ADDENDUM NO. 1

PROJECT NAME: BRACE HALL REMODEL PROJECT
UNL PROJECT NUMBER: C008P098
BID INVITATION NUMBER: 2205-13-7200

DATE OF ISSUANCE: September 9, 2013
DATE OF BID OPENING: September 19, 2013

MH101A

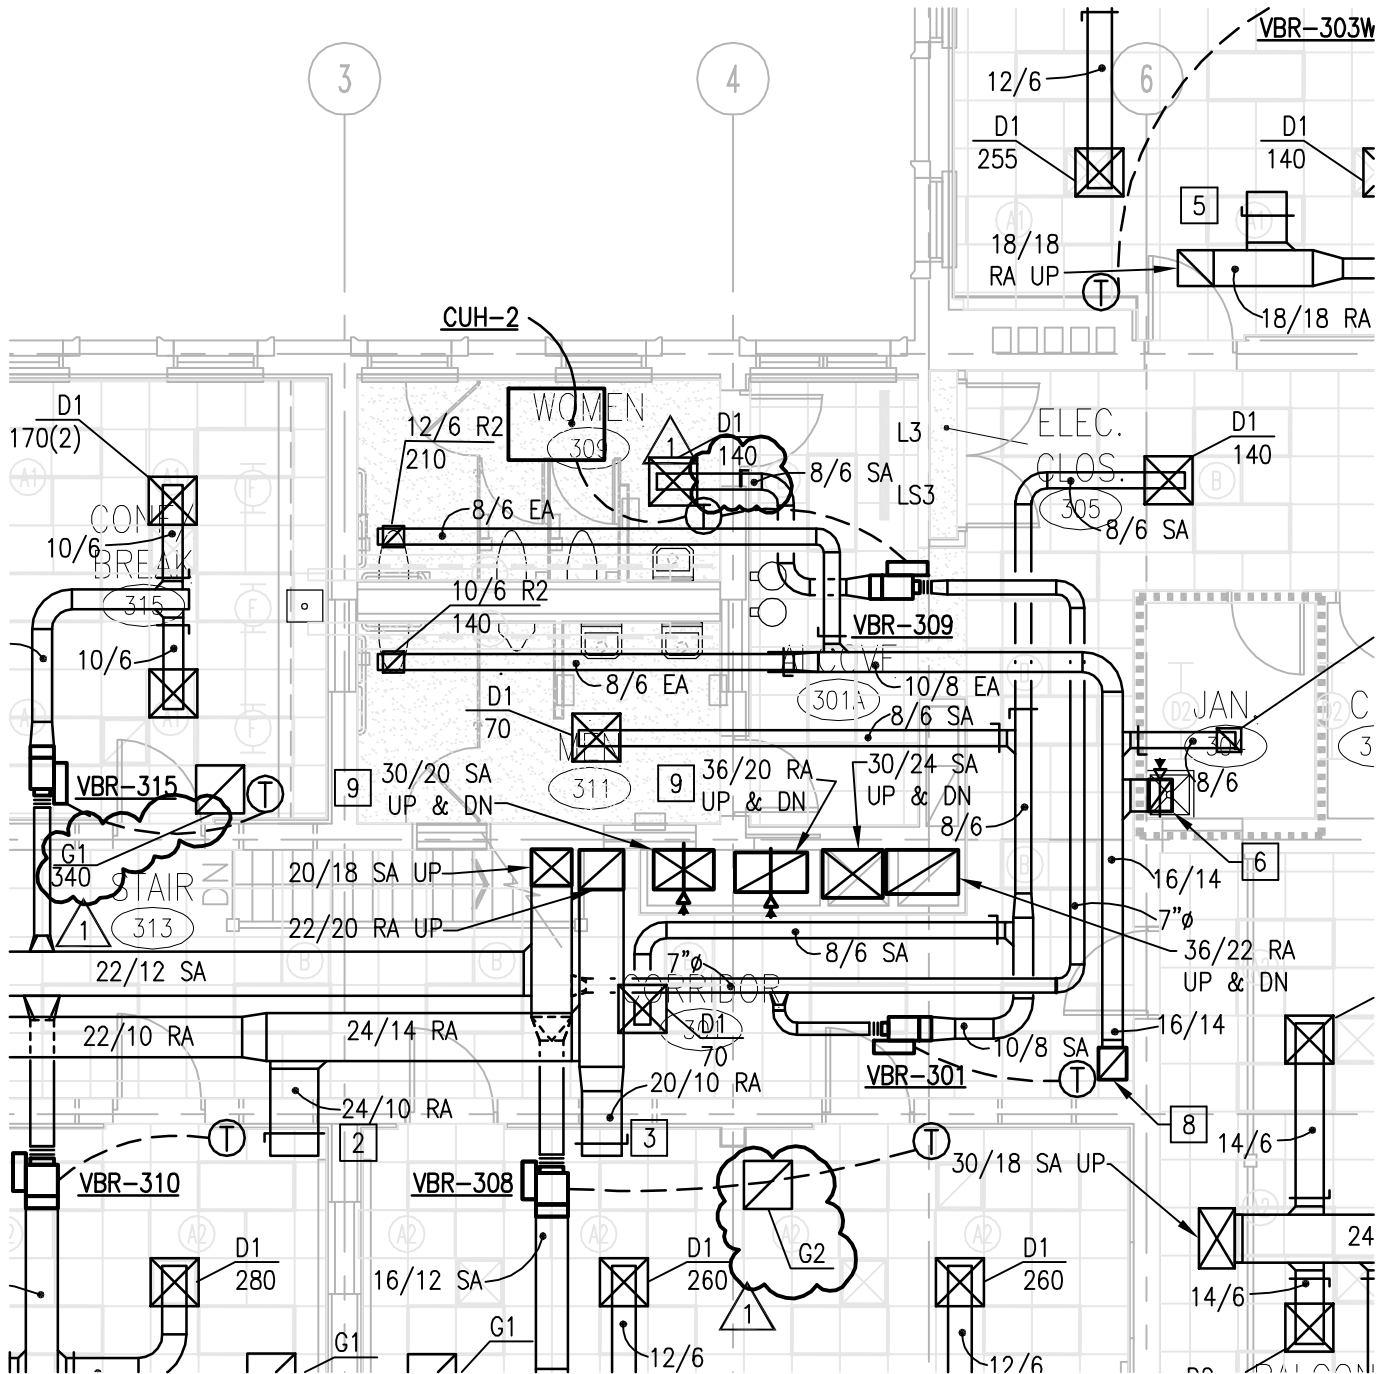
ITEM NO. M1-4 SHEET MH101 – FLOOR PLAN LEVEL 1 – HVAC
a) Diffuser and Grille Neck Size Schedule. Change note to read: "Where no grille size is shown, grille shall be type G2 unless shown otherwise.
b) Modify ductwork as shown on attached sketch MH101A

MH103A

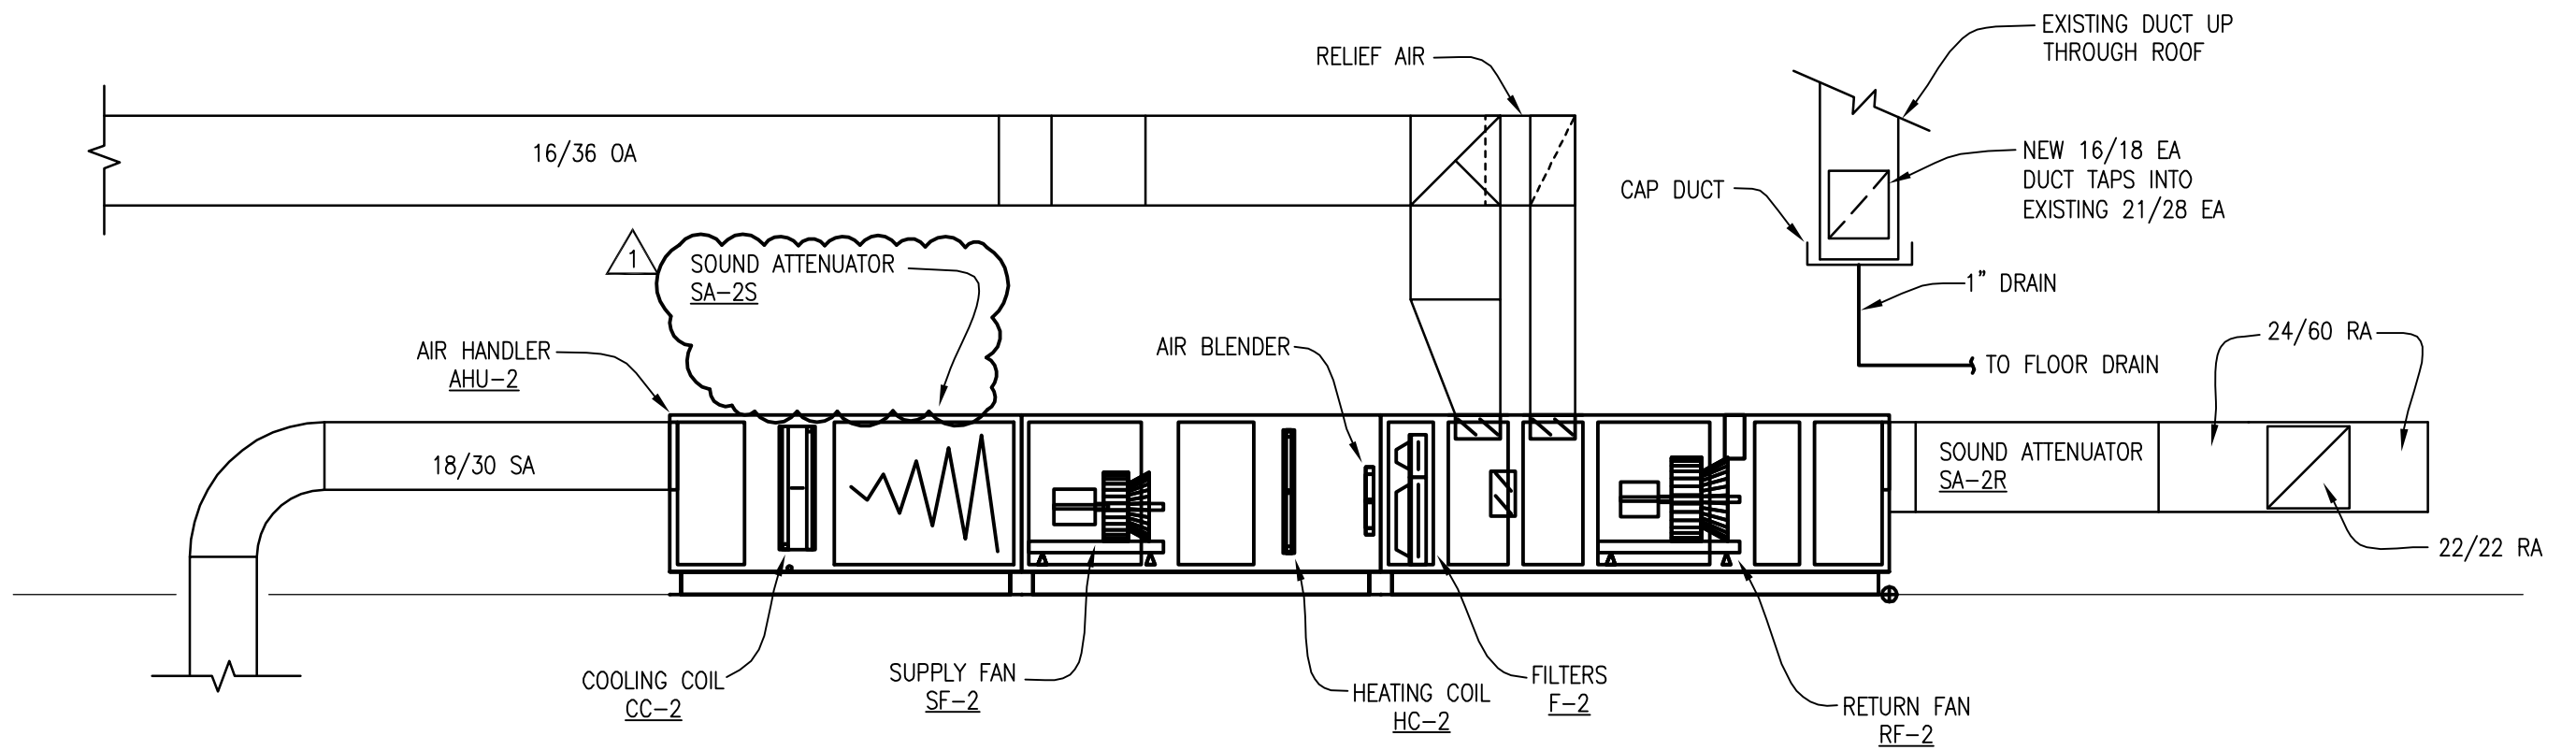
ITEM NO. M1-6 SHEET MH103 – FLOOR PLAN LEVEL 3 – HVAC
a) Diffuser and Grille Neck Size Schedule. Change note to read: "Where no grille size is shown, grille shall be type G2 unless shown otherwise.
b) Modify ductwork as shown on attached sketch MH103A.
